KIMBERLEY DESIGN

Observations

Discrepancies between Permit Drawings and Site Observations

Structural drawing of 2nd & 3rd floor

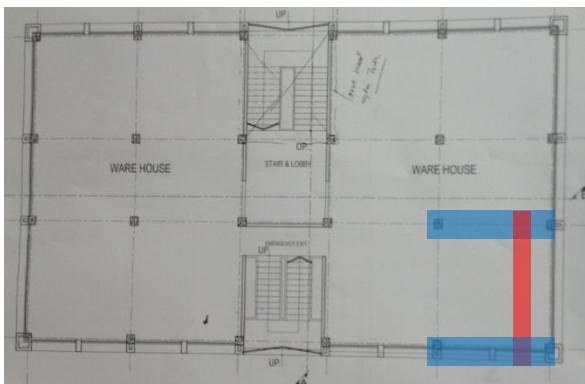
Observed columns which are shifted inwards after the 2nd floor.

Structural drawing of 1st floor

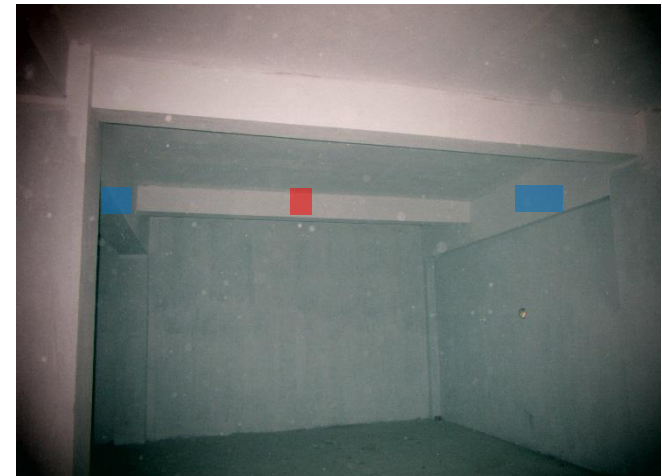
Shifted frame beam and transfer beams which are not present in permit drawings.

ITEM 1: Check the adequacy of the Transfer Beams on 2nd floor of the Warehouse Building.

Elevation drawing of Ware House Building

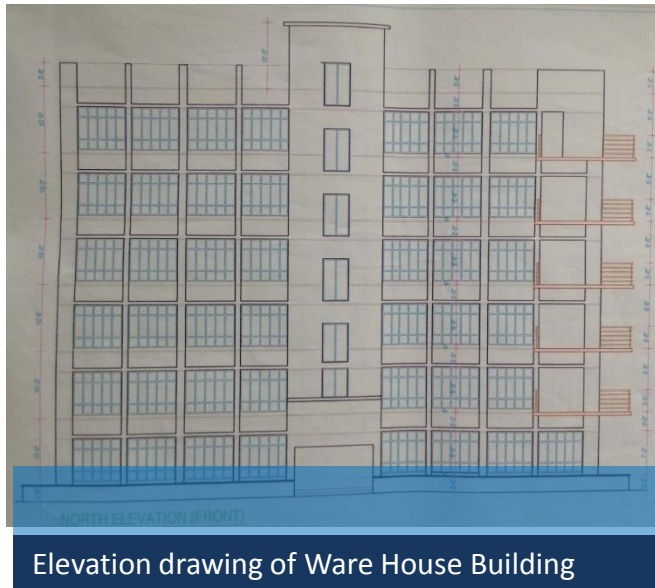
The basement was not shown on the permit drawings. Will be used for water tanks

Extra Two Floors not shown on
Permit Drawings : Basement and
Marked Floor

ITEM 3: Structural members in the water tank at the basement level of Warehouse Building should be waterproofed.
